0 to 45 dB Variable Gain Amplifier

Title		LIGO Laboratory California Institute of Technology Massachusetts Institute of Technology	
Size: B	DCC Number: D990694	PCB / SCH Revision: B	Engineer:
File: D:\MyFiles\Whitening_Filter\lsc_white_filt_sch\LSC White 3.sch		Date: 27-Nov-2002	Time: 14:00:00
		Sheet 3 of 12

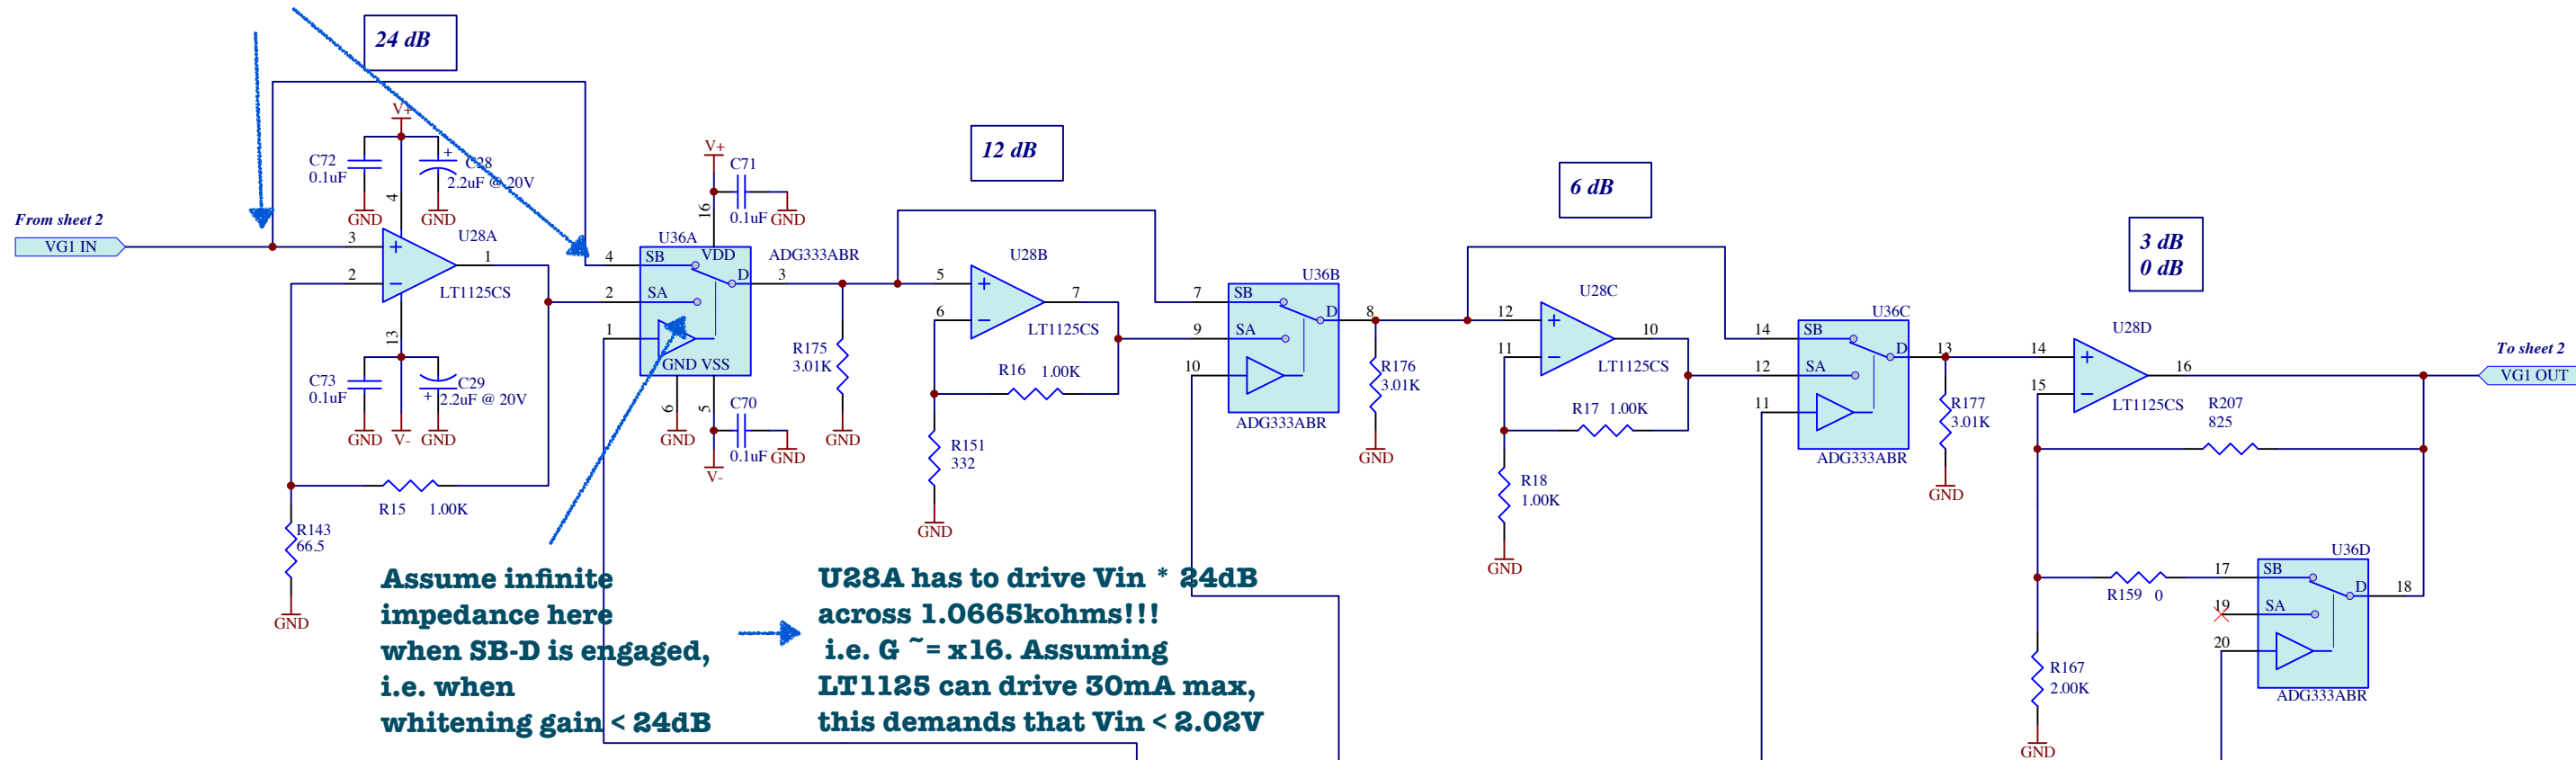
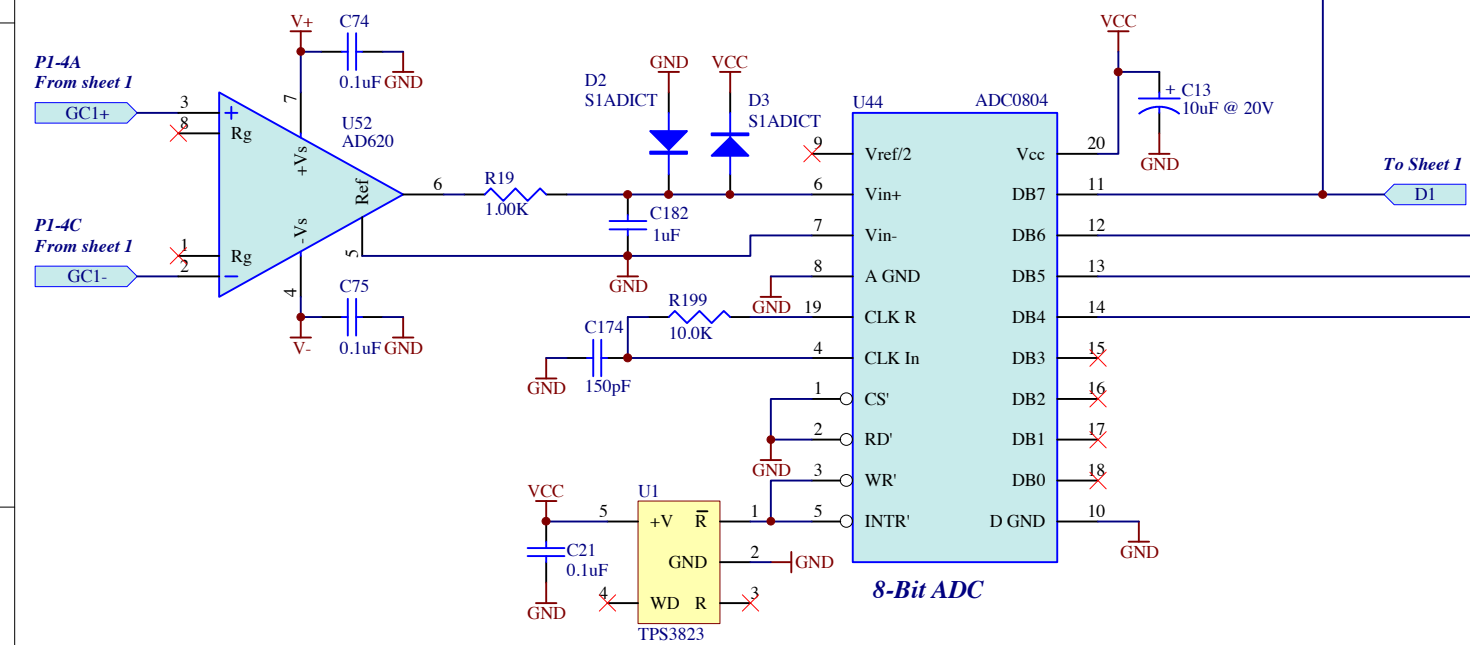
Same potential!

Assume infinite impedance here when SB-D is engaged, i.e. when whitening gain < 24dB

U28A has to drive $V_{in} * 24dB$ across 1.0665kohms!!! i.e. $G \sim = x16$. Assuming LT1125 can drive 30mA max, this demands that $V_{in} < 2.02V$
